Product Change Notification

PCN-PCC-8042-2022

Business Unit	Product Line Code	Type of Change	Action	Date of Issue
PCC - PCB Connectors	AAC	Product Change Notification	Notify Distributors and Field	7/18/2022

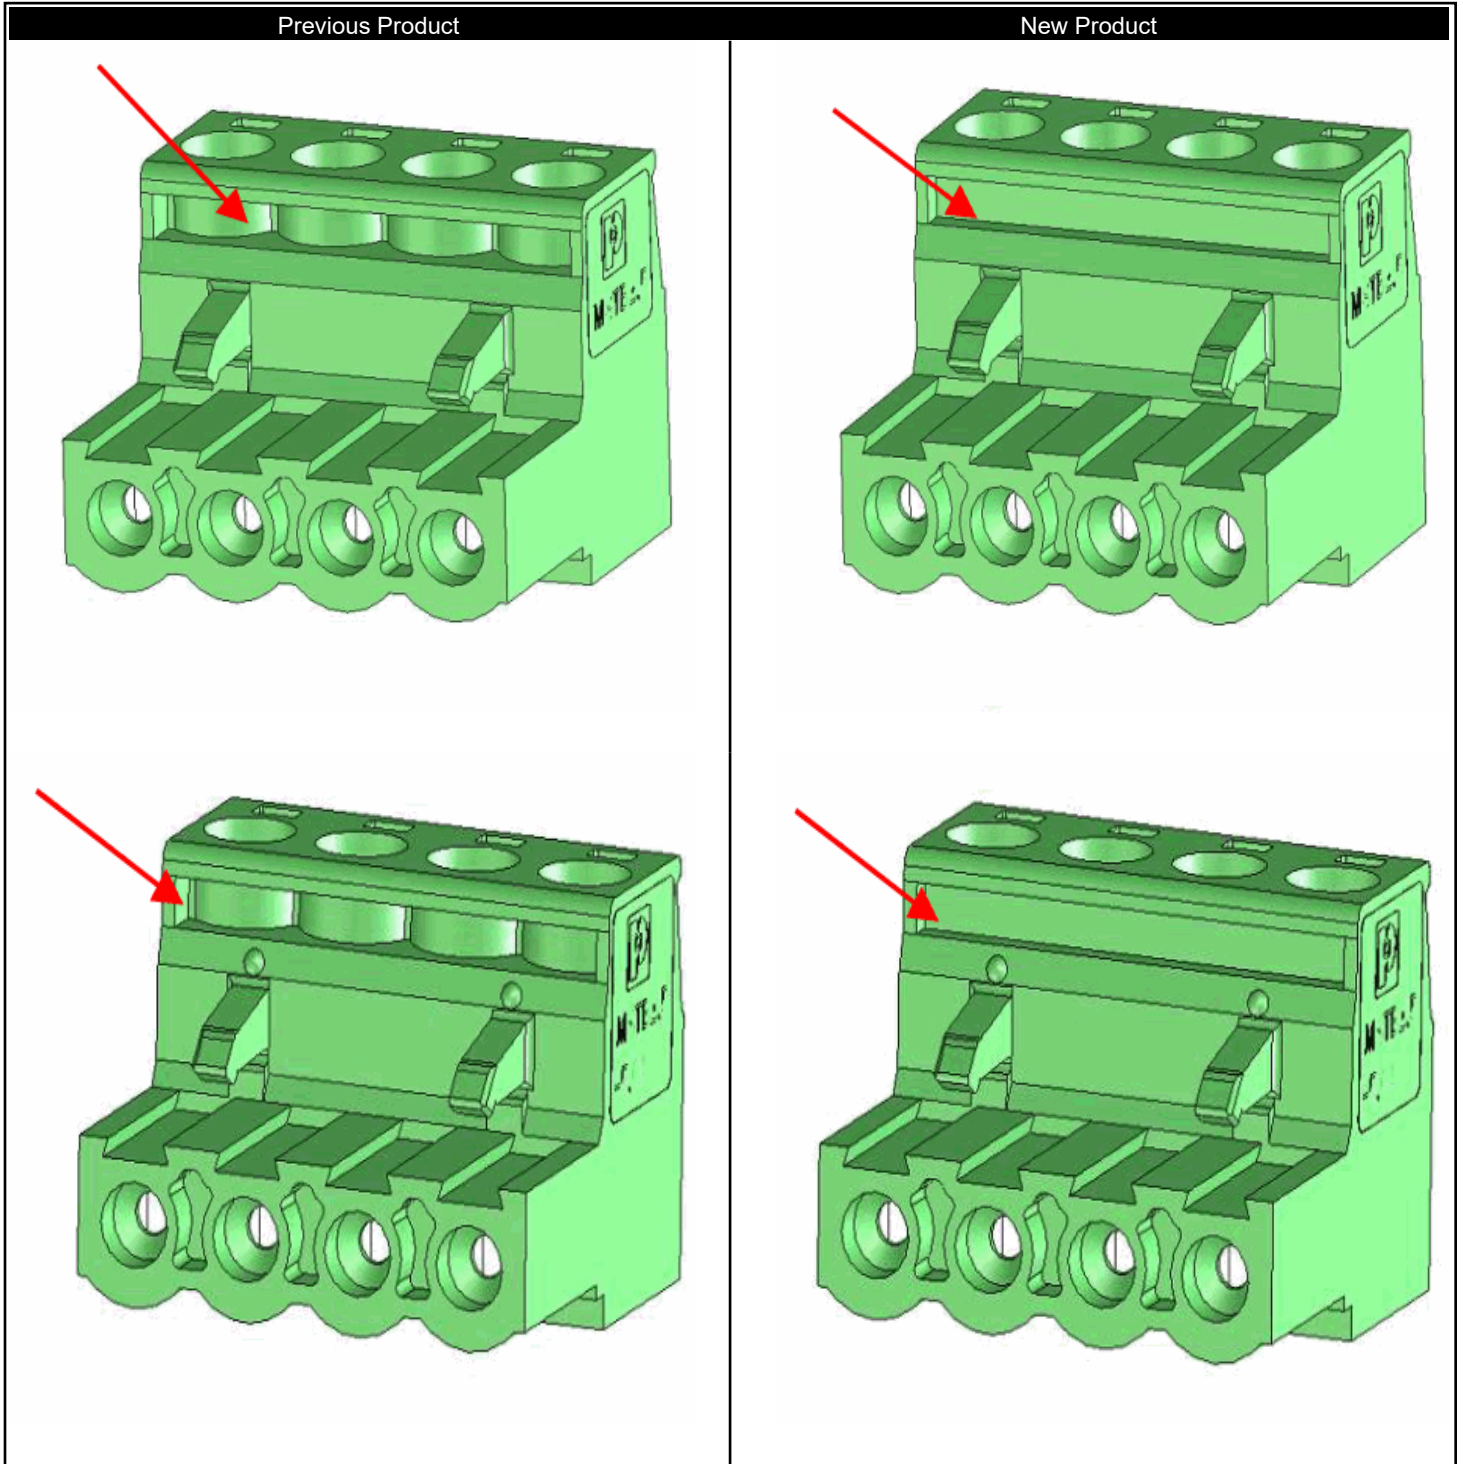
With the construction of new injection molding tools, the design of the material displacement of the MSTB 2,5/ connectors without flange system with 2-position through 10-position will be adapted to match that of the high-position connectors and those with flange system. A visual comparison of old/new is provided below in this document. The external dimensions, technical data, and approvals remain unchanged. The existing tools will continue to produce the old design. This will gradually be replaced with the new contour over the coming years.
